STATE OF WASHINGTON
DEPARTMENT OF ECOLOGY

November 8, 2016

**Re: Opinion pursuant to WAC 173-340-515(5) on Remedial
Investigation/Feasibility Study for the following Hazardous Waste Site:**

- **Name:** Hers Industrial Park
- **Address:** 4403 Russell Road, Mukilteo, WA 98275
- **Facility/Site No.:** 127256
- **VCP Project No.:** NW1554
- **Cleanup Site ID No.:** 3971

PROJECT NO.	OCT-2015	FIGURE NO.	2
	REVISED BY	ASL / RNP

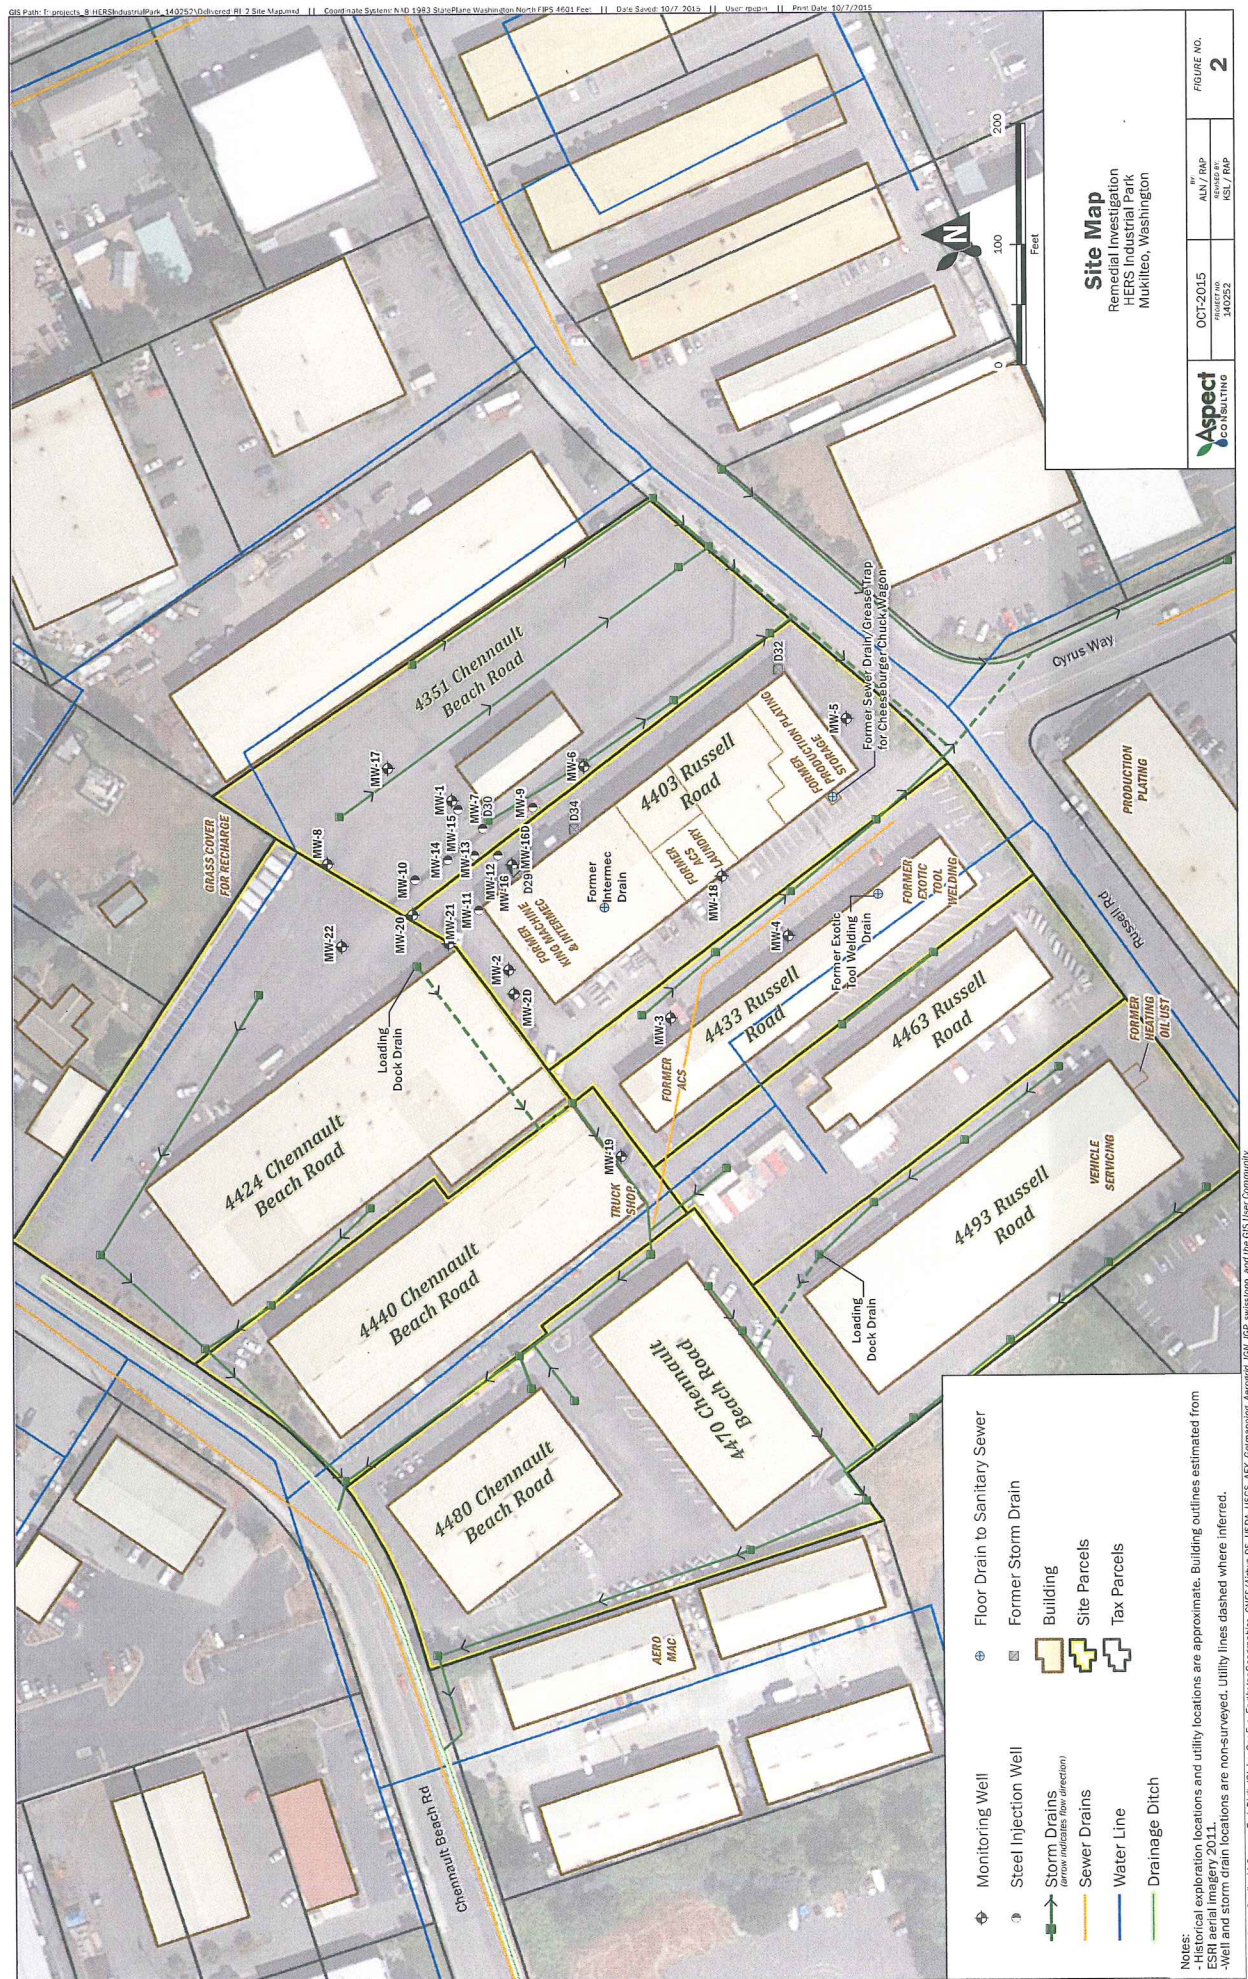
- Please show and label the surrounding industrial property locations (described in Section 2.3) that are adjacent or near the Site on Figure 2 (Production Plating is shown but two addresses are provided in the text) or on a separate figure. Industrial land uses on adjacent parcels should be described.
